From: Corey Baldwin
Sent: Monday, 17 October 2016 4:25 PM
To: Johannes.Grobler@brisbane.qld.gov.au
Cc: 'Jaimee.Boutcher-Hann@brisbane.qld.gov.au'; [REDACTED]
[REDACTED] Wendy Brewster
Subject: Northshore Hamilton Interim Bus Stops
Attachments: NSH Masterplan Overlay all layers 20102014.pdf; Bus stop location options.docx

From: Corey Baldwin
Sent: Friday, 11 November 2016 9:49 AM
To: John Kakourakis
Cc: [REDACTED]
Subject: Northshore Hamilton - Remora Road roadworks - Gas Relocations
Attachments: 12191C-201611101419.zip

From: Chris Mancini [mailto:Chris.Mancini@brisbane.qld.gov.au]
Sent: Tuesday, 31 January 2017 9:55 AM
To: [REDACTED]@translink.com.au); Corey Baldwin
Subject: Route alignment at Northshore Hamilton

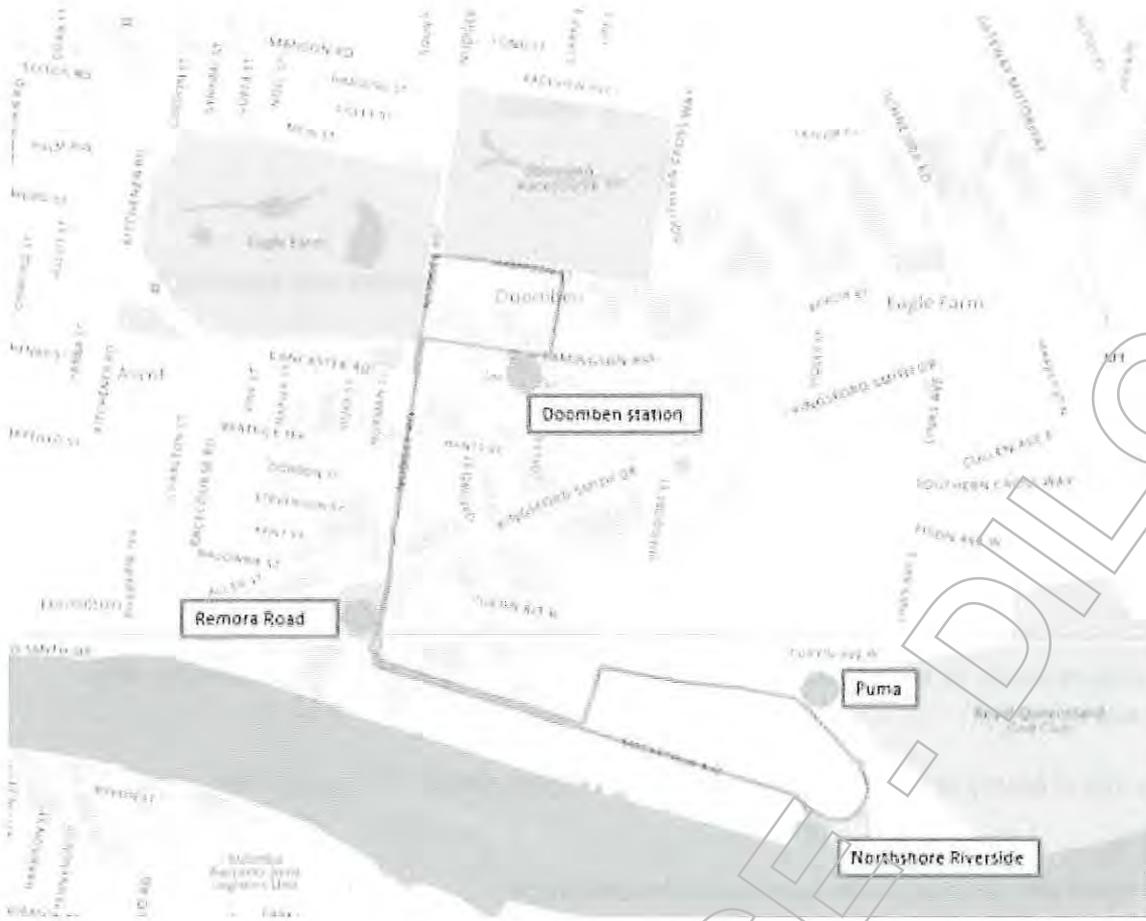
There is a matter that I would like to respectfully bring to your attention about a concept loop via Barcham St and Macarthur Ave (refer image attached below).

The same situation will happen with the concept loop at Northshore Hamilton.

With the concept loop via Barcham St, passengers would board at the bus stop near the BTP Puma Energy office.

However they will be required to disembark at the bus stop near the Northshore Hamilton ferry terminal because the Bus Operator might need to use the facilities, or the bus might have arrived early, or there might be a "bus swap", etc.

This is the background about why I recommend the route continues along Macarthur Ave, turns around at the roundabout near the BTP Puma Energy office, and terminates at a new bus stop near the roundabout.
